**SYDNEY METRO CITY & SOUTH WEST
 CONSTRUCTION TRAFFIC MANAGEMENT PLAN
 CHATSWOOD DIVE SITE**

MAY 2017

CTMP Review Comments Sheet

SYDNEY METRO

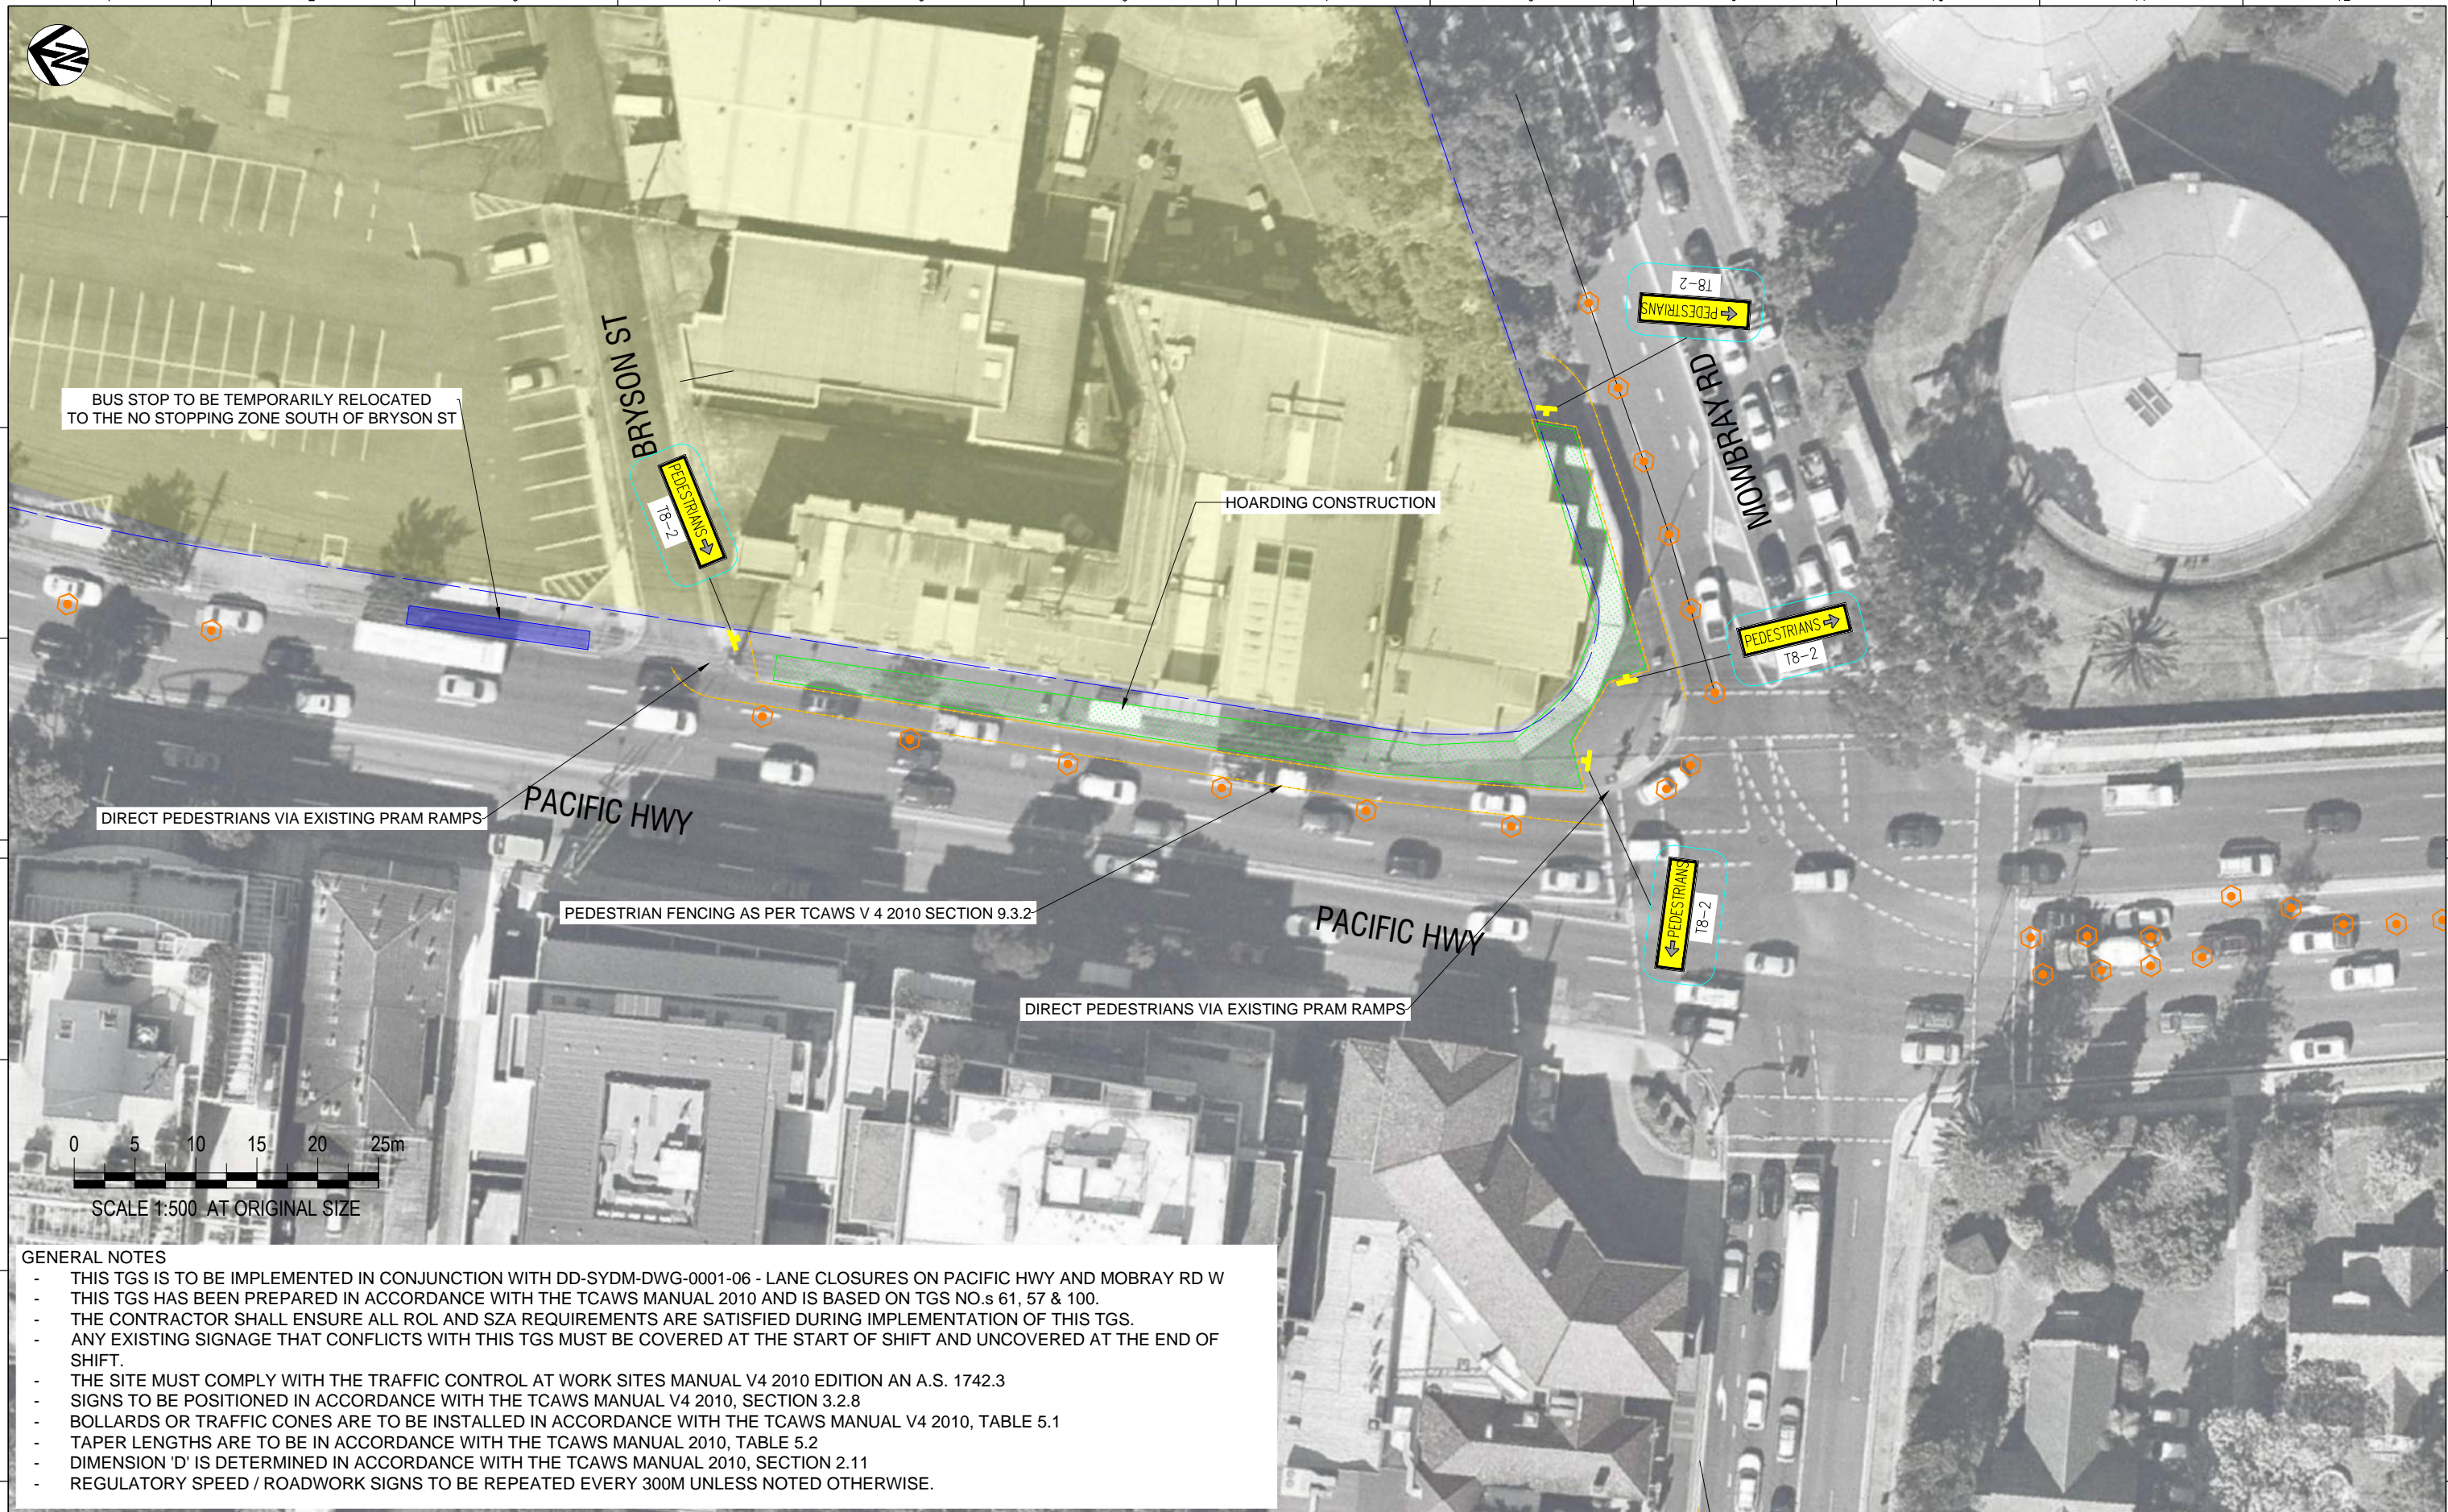
Item	Section/ Page	Comments	Response
1	Pages 22 and 26	What is the significance of the areas shown in bright green on page 22 and 26? What are the orange areas? What are the orange dots?	the bright green areas are: DWG-0001-6 Sheets 1 and 2- lane closure DWG-0001-07 - swept path orange dots are bollards
2	Page 24	On page 24 it is indicated that pedestrians must move to the right. Does that mean pedestrians should use the footpath on the other side of Pacific Highway? If so how will pedestrians be protected from traffic?	the pedestrians would be within the closed lane - if you would like the pedestrians detoured then please confirm
3	Appendix 5	Do you have the Road Safety Audit referred to in Appendix 5 (blank)	Included in current document

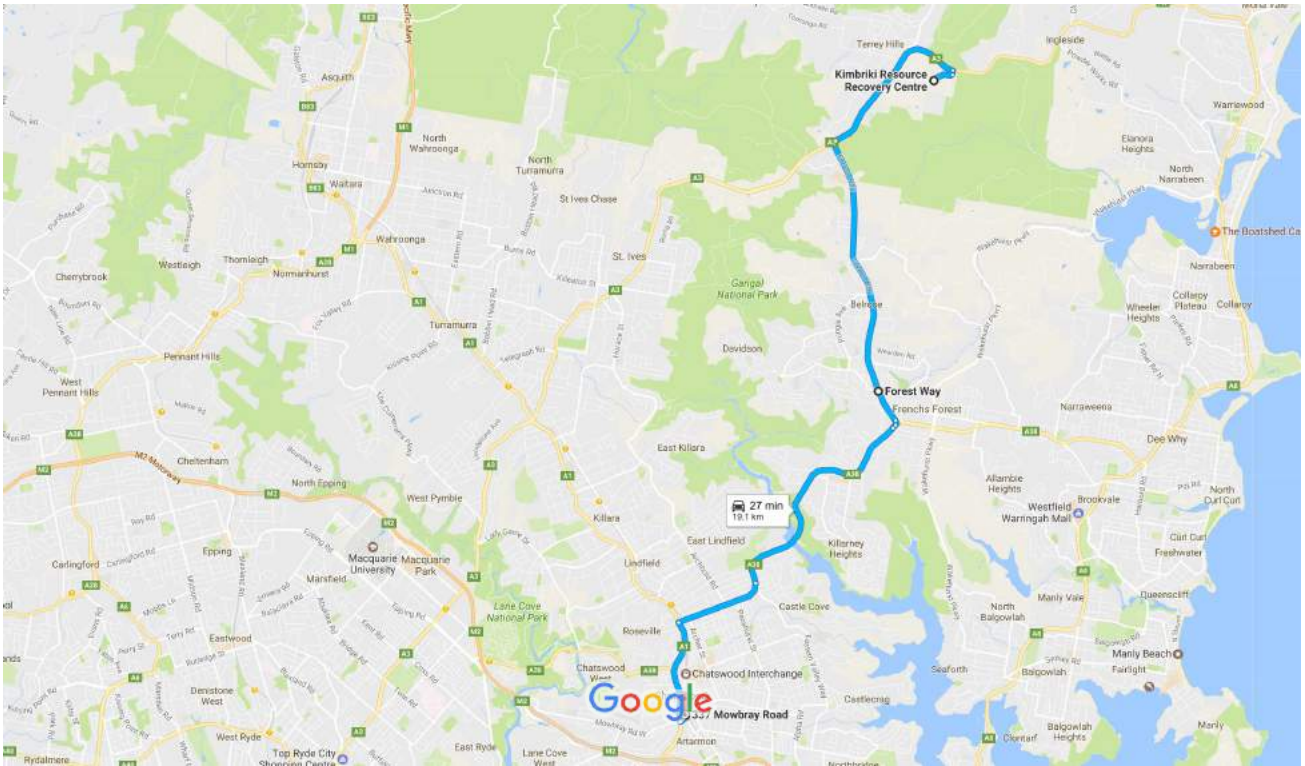
Item	Section/ Page	Comments	Response
15	Appendix 4	Logistics routes, Kimbriki to Mowbray Road – Should either be along Mona Vale Rd, Forest Way, Warringah Road, Boundary Road to the Pacific Highway at Chatswood or Mona Vale Road to the Pacific Highway at Gordon.	Drawing amended as per direction

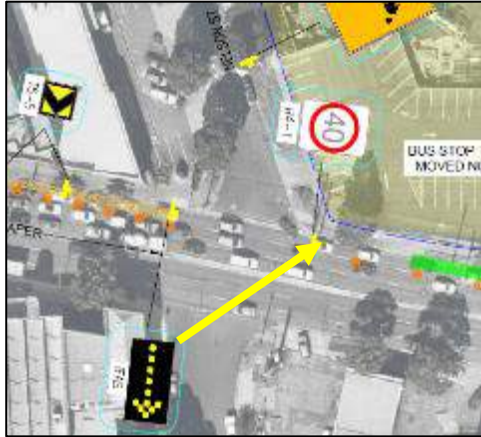
Point No.	Issue	Suggestion	Delta Group (Sue Lewis Consulting) Response	
			Accept / Reject	Comment / Status
General: It's considered that the key <i>road safety</i> issue with this CTCP Site Establishment Plan (CTCP sheet 19) is the management of the footpaths in the long-term with regard to visibility, light, sight lines, trip hazards and so on.				
1.	It's unclear whether 'chainwire fencing' on the plan refers to standard temporary fencing. If it does, temporary fence bases often can be trip hazards within pedestrian paths.	Consider aligning bases with fence and providing other means of lateral fence support. Alternatively, bump rails can steer pedestrians away from the supports. Examples below.	Reject	The temporary fencing will be installed into the ground and there is no need for temporary bases

Point No.	Issue	Suggestion	Delta Group (Sue Lewis Consulting) Response	
			Accept / Reject	Comment / Status
2.	Similar to point 1, the specific details are unclear for the support feet of the hoarding (as it connects to the ground).	Ensure they are not trip hazards (e.g. white / left) or that trip hazards are 'buffered' (e.g. yellow / right). Examples below.	Accept	Hoarding footings will be placed to not impact pedestrian movements
 <p data-bbox="248 794 533 820"><i>Examples of trip hazards</i></p> <p data-bbox="1406 794 1664 820"><i>Trip protection device</i></p>

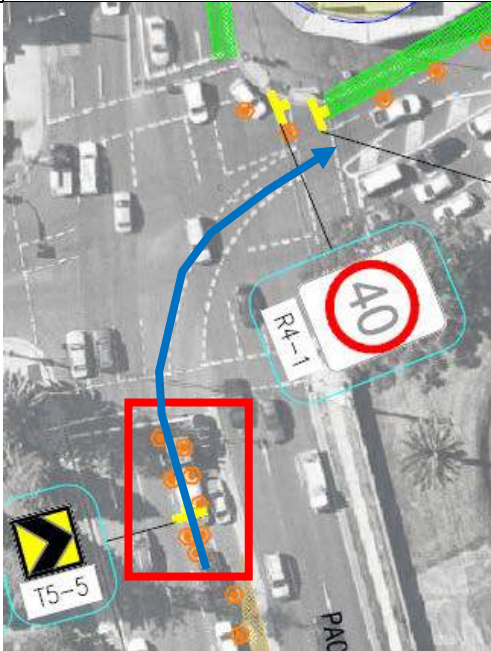
Point No.	Issue	Suggestion	Delta Group (Sue Lewis Consulting) Response	
			Accept / Reject	Comment / Status
6.	<p>Plan 0001-06: T5-5 signs mounted in frames can be awkward in these small 'wedge' areas.</p> 	<p>Consider using collapsible chevron delineators for this purpose.</p> 	Accept	Note added to drawing

Point No.	Issue	Suggestion	Delta Group (Sue Lewis Consulting) Response	
			Accept / Reject	Comment / Status
7.	<p>Plan 0001-06: Further to the above point, in the experience of RSA P/L, sometimes these small lateral shifts into the 'correct' turn lane are more trouble than they are worth unless they are exceptionally clear, well set up with good approach site distance and maintenance of knocked over devices.</p>	<p>An alternative worth considering is closing the right turn lane only, resulting in no driver decision, or lateral shifts, or knocked over traffic devices into active lanes.</p> <p>Although drivers are in the 'incorrect' turn lane, it's very easy to see the closed Mowbray Rd lane due to the flashing arrow / other devices, and drivers tend to gently shift over without difficulty.</p> <p>Consider this option.</p>	Reject	This set up is done to limit worker exposure to traffic and for maintenance of the bollards
